COMMUNITY DEVELOPMENT DEPARTMENT REPORT

HEARING 11/6/2025
DATE: *Vacated from 3/20/2025 agenda;
continued from 10/2/25*
TO: Planning & Zoning Commission
FROM: Sonya Allen, Associate Planner
208-884-5533
sallen@meridiancity.org
APPLICANT: Brighton Corporation
SUBJECT: H-2024-0061
Apex Cadence (aka Pinnacle) – ALT,
MDA, PUD, PP, RZ, PS
LOCATION: 6575 S. Locust Grove Rd., in the NE 1/4
of Section 6, T.2N., R.1E. (Parcel
#S1406110355 & a portion of
#S1406110016)

G. Preliminary Plat (dated: 10/9/24) & Phasing Plan

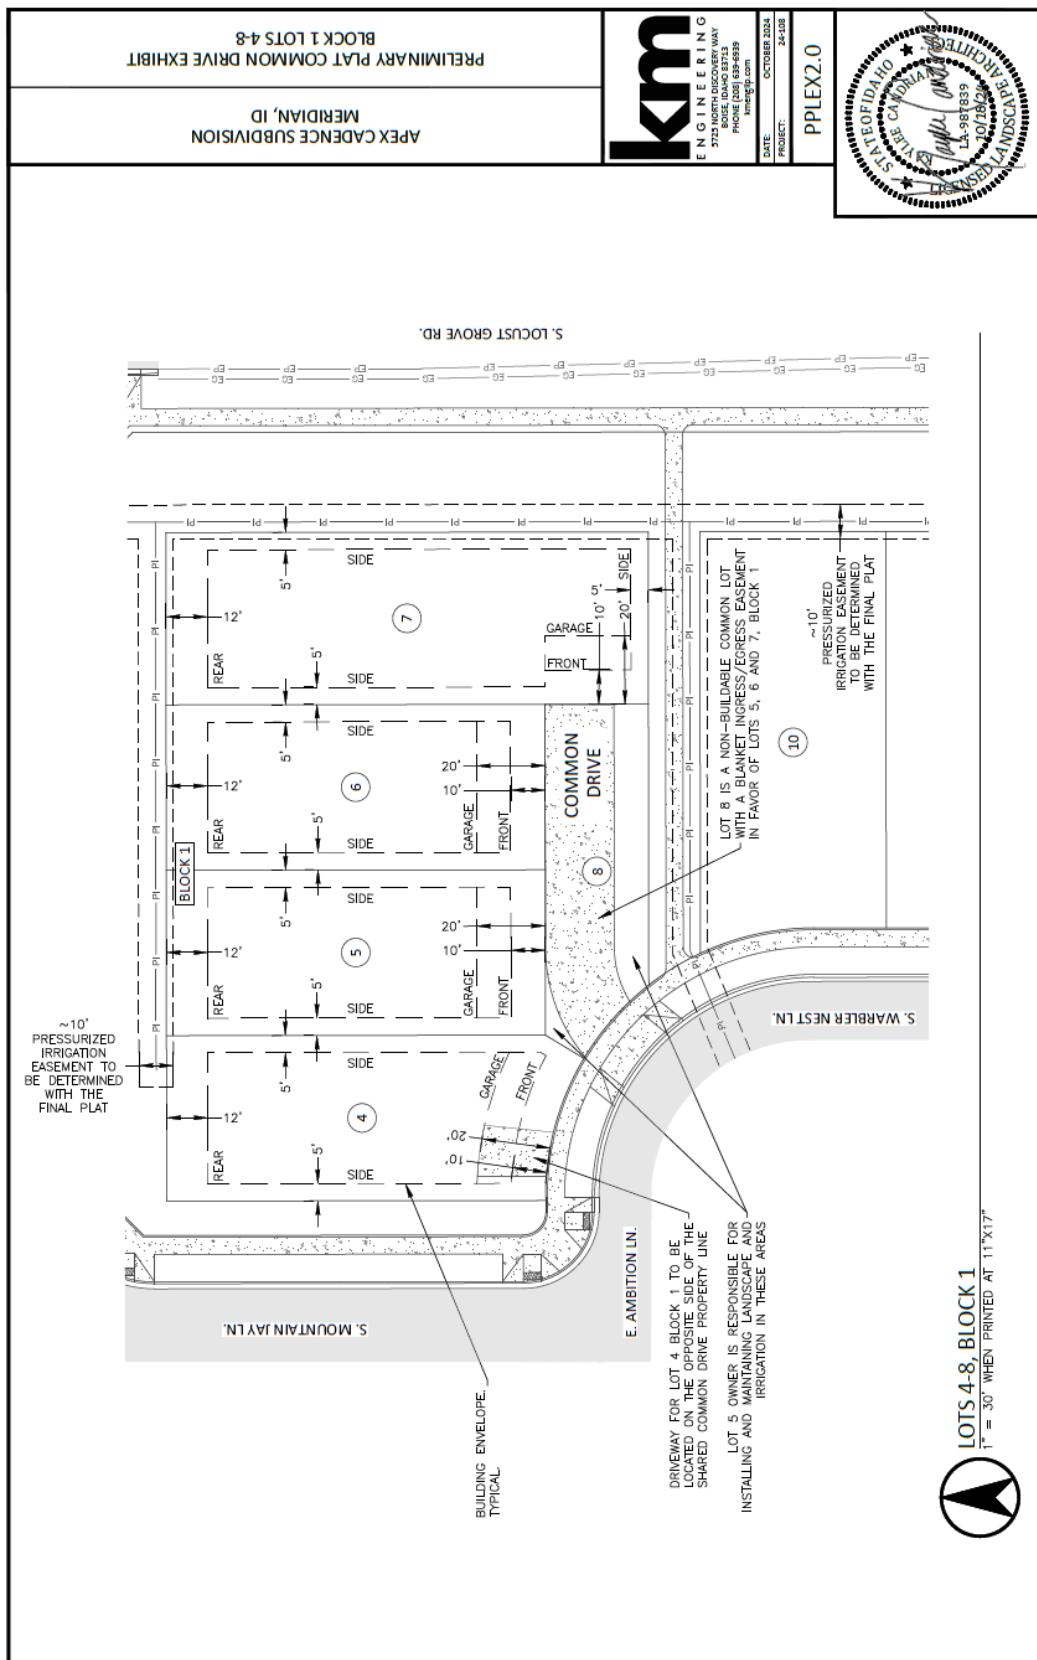
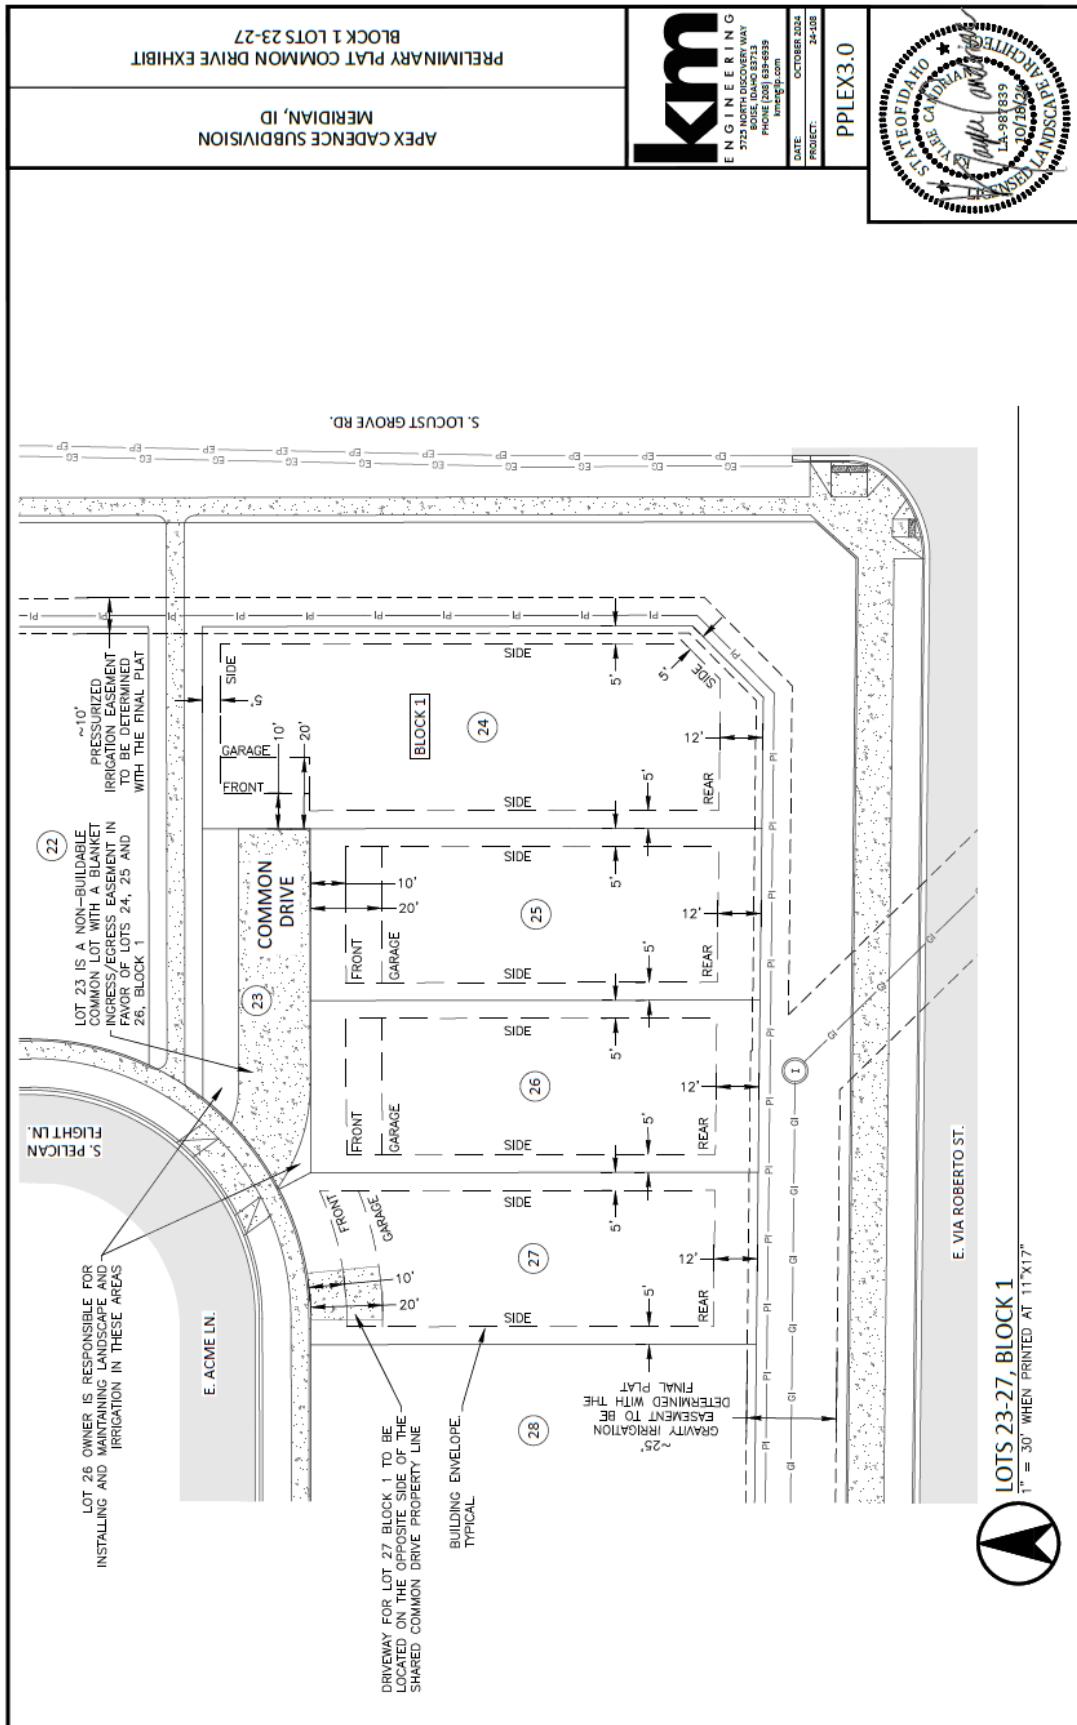
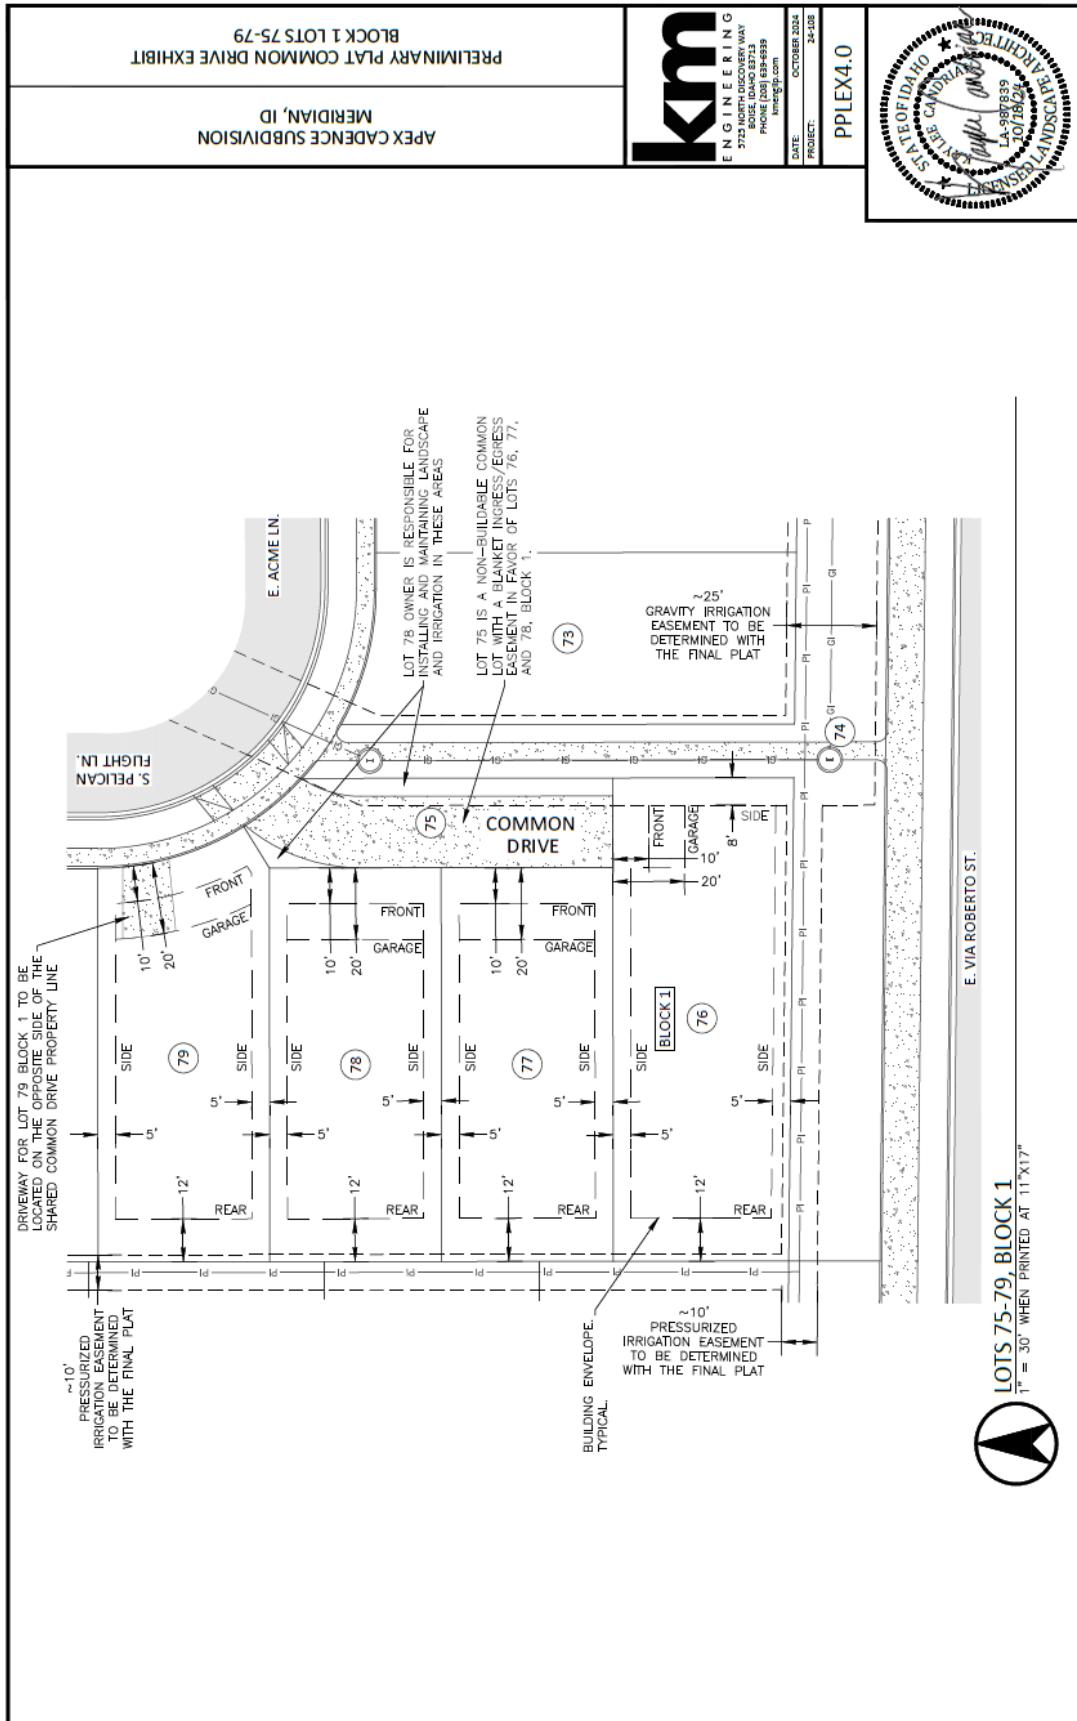
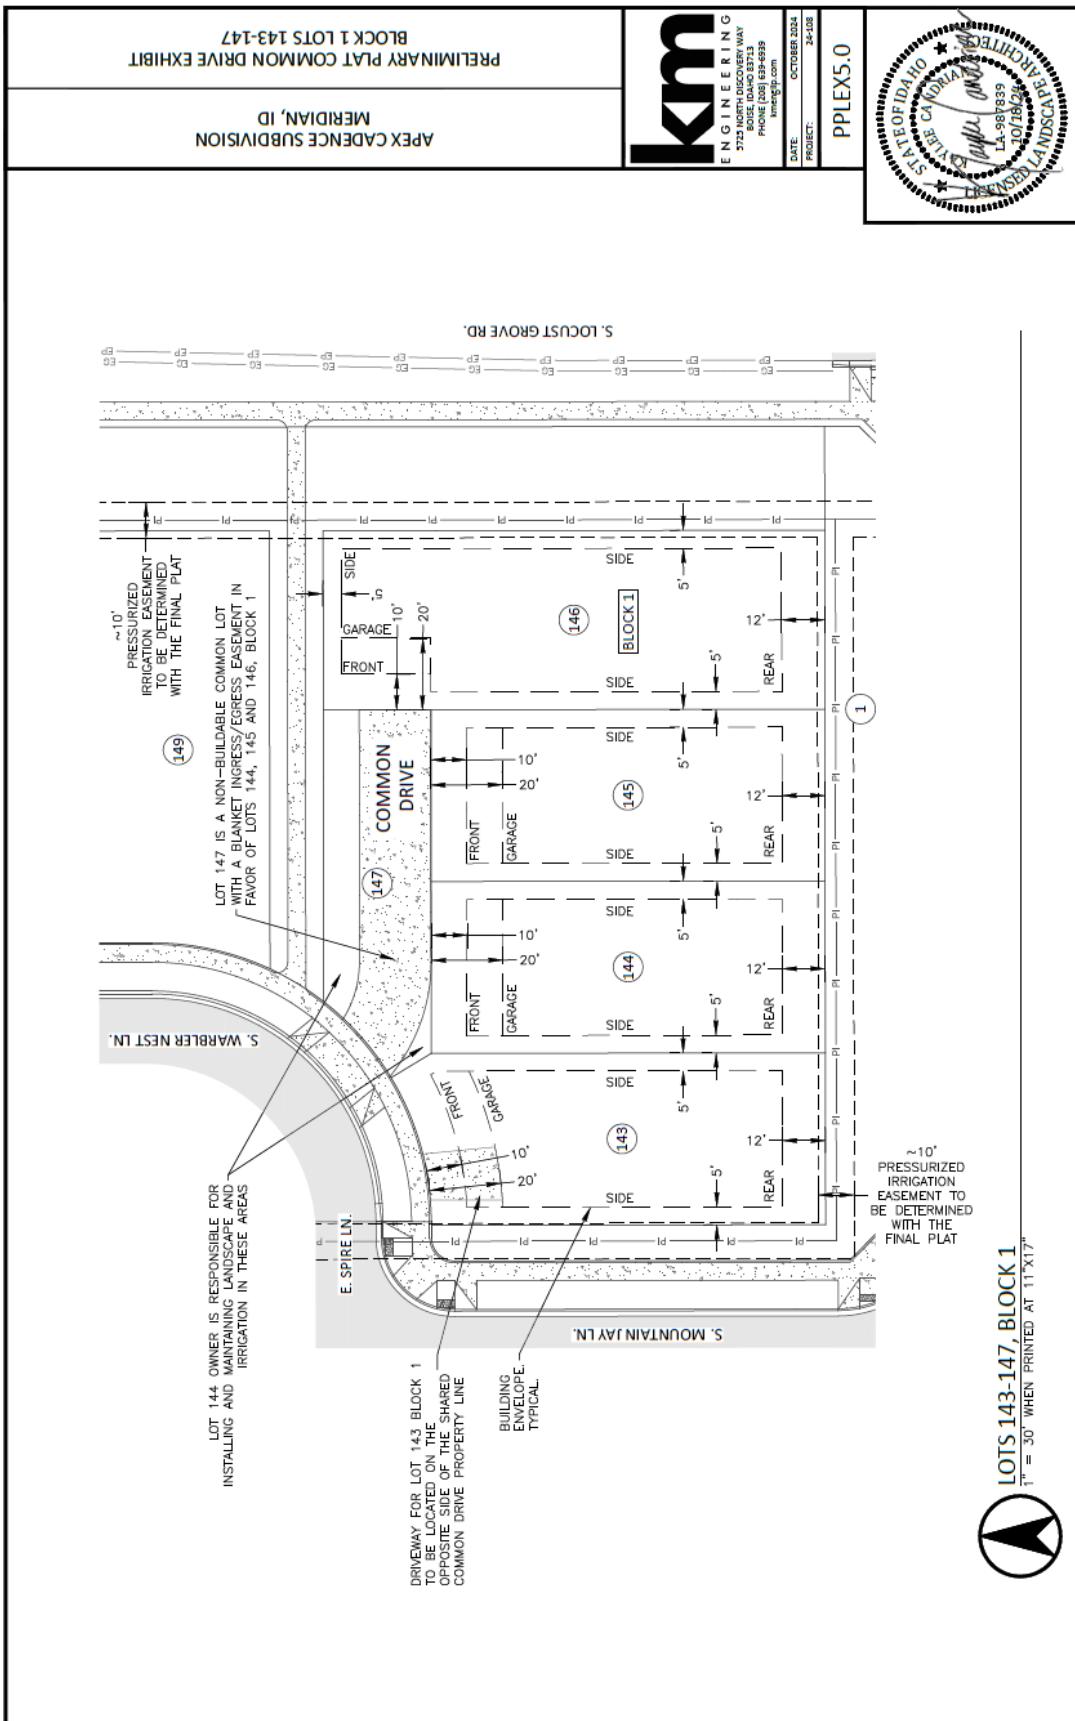
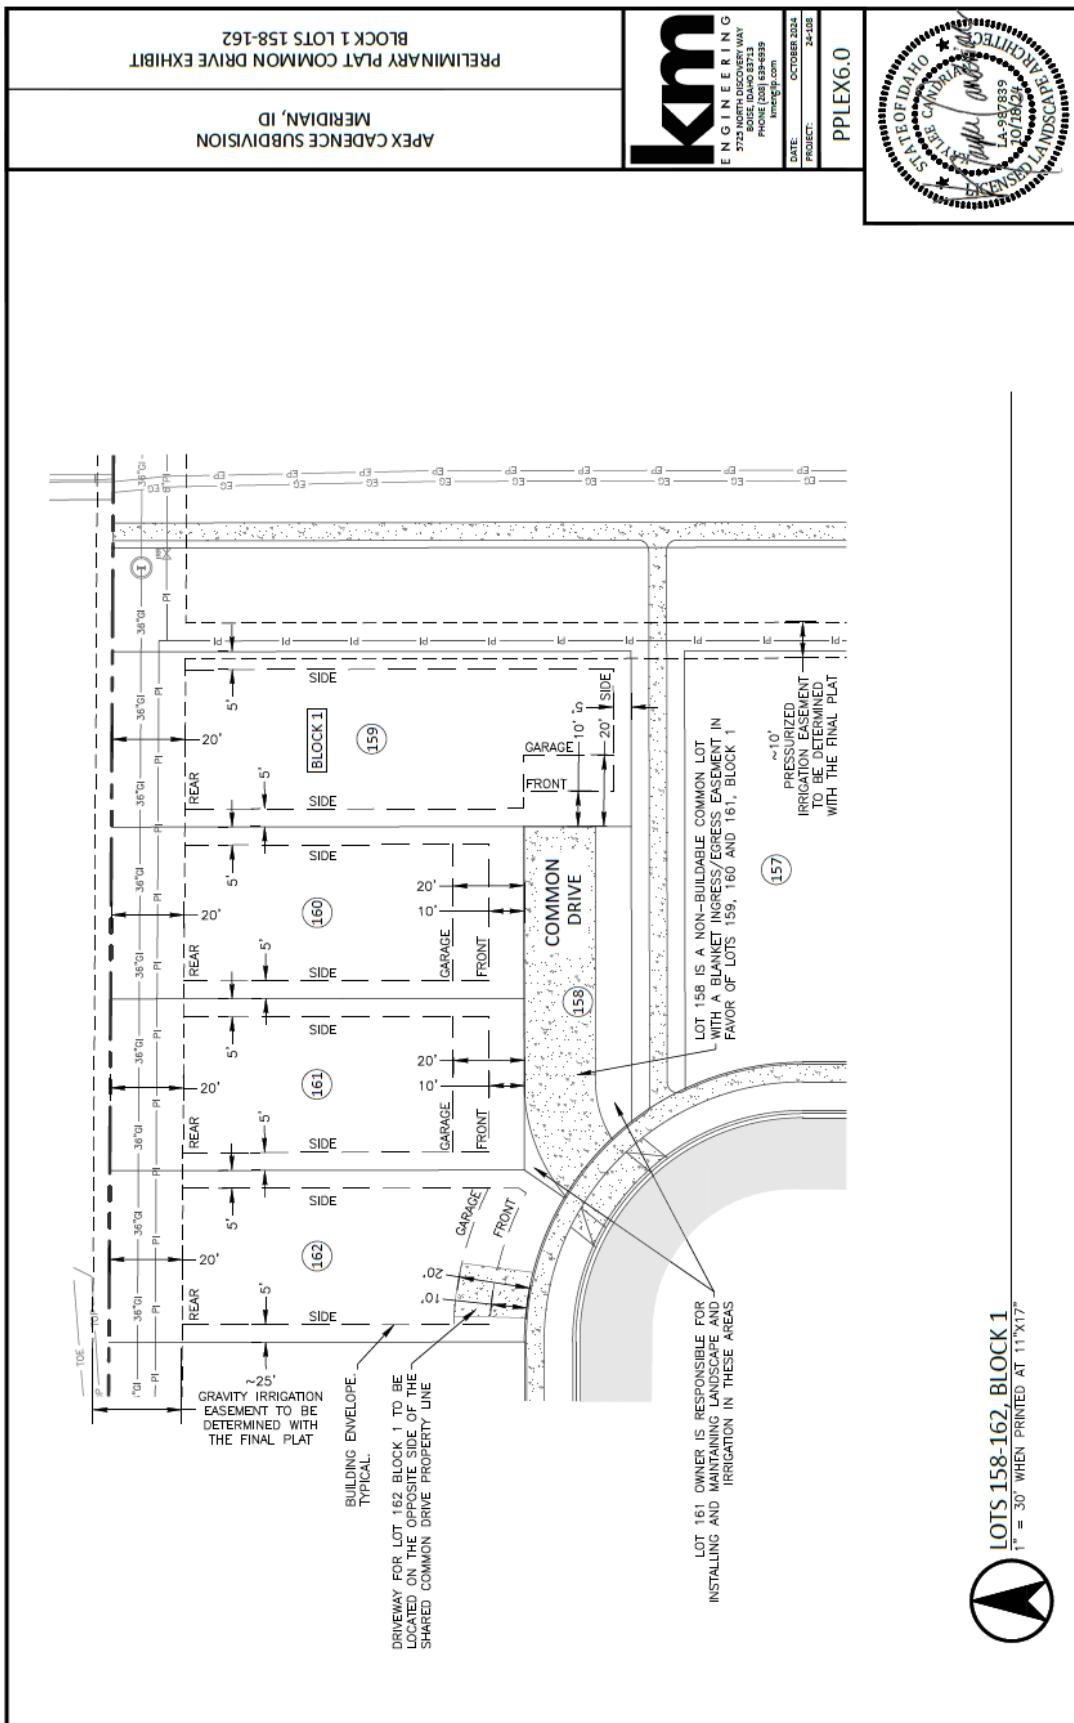
- Include the small triangle areas between the common driveways and adjacent building lots in the adjacent building lots; revise the plat accordingly. Provide a 28-foot inside and 48-foot outside turning radius in accord with UDC 11-6C-3D.6.

Alleys are required to comply with the standards in UDC 11-6C-3B.5. The proposed 20-foot-wide alley street sections depicted on the plat comply with these standards. A turning radius exhibit was submitted that demonstrates the entrance to the alleys from the private streets provide a minimum 28-foot inside and 48-foot outside turning radius as required by the Fire Dept. **Wayfinding address signage should be provided at the private street for homes accessed via alleys that don't have frontage on a named street (i.e. Lots 96, 97, 99-103, Block 1 and Lots 224-231, Block 1).**

The Watkins Drain bisects this site north/south and is being relocated along the Rawson Canal and will either be piped or remain open per the preliminary engineering plans; **the easement should be depicted on the plat.**

- vi. Remove one (1) of the building lots within the area of Lots 260-263, Block 1 to comply with UDC 11-6C-3D.1, which allows a maximum of three (3) dwelling units to be located one (1) side of the common driveway.

- viii. Depict a minimum 10-foot-wide multi-use pathway along the Rawson Canal, including along the cul-de-sac to the west boundary of the site alongside E. Adler Hof St., in Lots 88 and 276, Block 1 in accord with UDC 11-3A-8G and the Pathways Master Plan.

- xii. Depict private streets on a single platted lot that provides access to all properties served by such private streets.
- b. The landscape plan shall include the following revisions:
